LOCAL HISTORIC DISTRICT: Dilworth

PROPERTY ADDRESS: 1119 Belgrave Place

SUMMARY OF REQUEST: Window changes

HDC REVIEW

BAY WINDOW ELEVATION

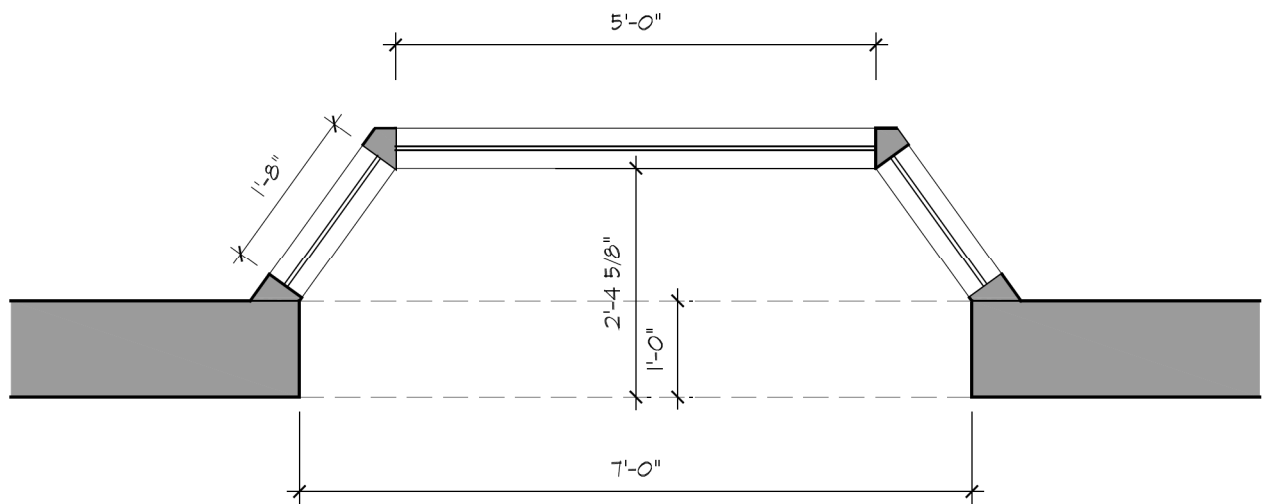
1. Bay windows are not-incongruous with the Colonial Revival style of architecture.
2. The proposed project meets guidelines for Materials 6.15.
3. The Commission will determine if the proposed window change meets guidelines and is not incongruous with the district.
4. Minor revisions may be reviewed by staff.
